From: Angela Jolliffe [REDACTED]
Sent: 27 January 2017 16:43
To: Hilary Kernohan; David Innes
Cc: Claire Potts
Subject: Redraw Pollards Nursery Site BN/66/16/DOC, BN/52/16/Res (51/16)

Further to my previous emails relating to the Redrow Application for a revised layout, please see below relating to the Reptile habitat.

FOR LANDS PLANNING, BARRIUM - SITE LAYOUT

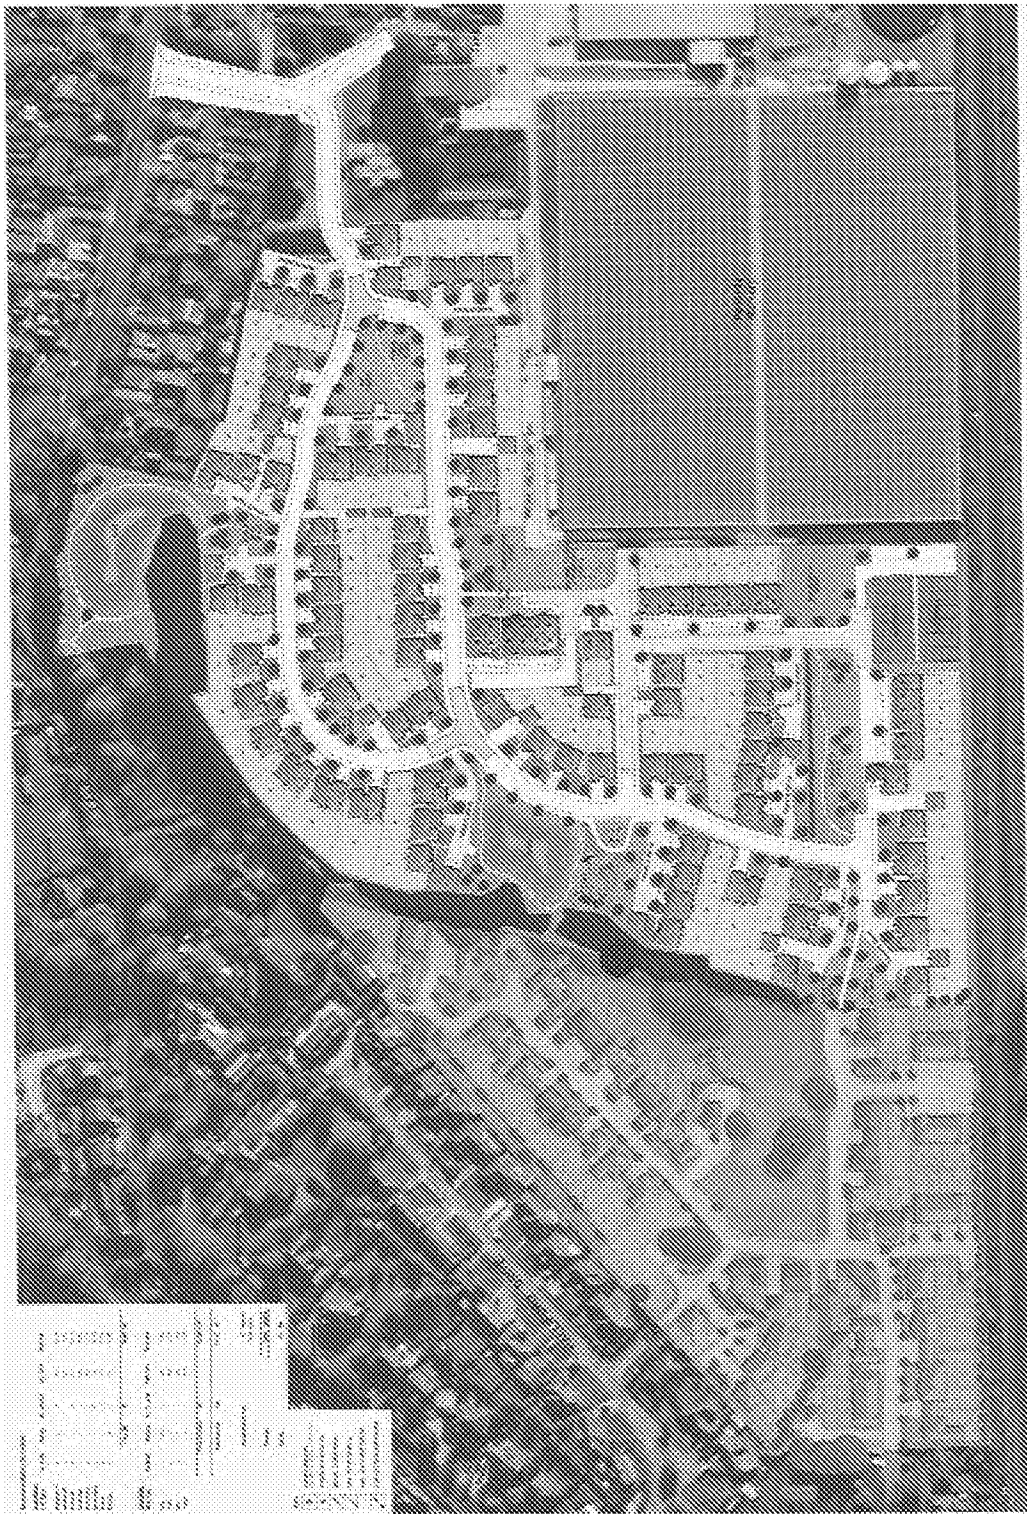
Redrow's plans, to scale, show hedging/greenary extending some 10-14 meters inside the Western boundary of their site. The attached plan shows the reptile habitat to be Retained along the western Boundary (including the substantial reptile habitat along the southern boundary which is to be removed).

Unfortunately, Redrows plan to build 4 houses dissects the Habitat to be retained along the Western Boundary in Figure 3 attached.

In addition the Highgate property they are proposing to build nearest the Western Boundary is 2.5 story. The light spill from this property will encroach on the 10m Bat Commuting and Foraging zone identified in my previous email.

With regards to the Tree T22 on the RPS Drawing 717, dated 15/11/2016, this tree does not appear to be present on the site. I will forward you some current site photos shortly.

Furthermore there is currently no specific reptile exclusion fence along the western boundary, only site fencing.
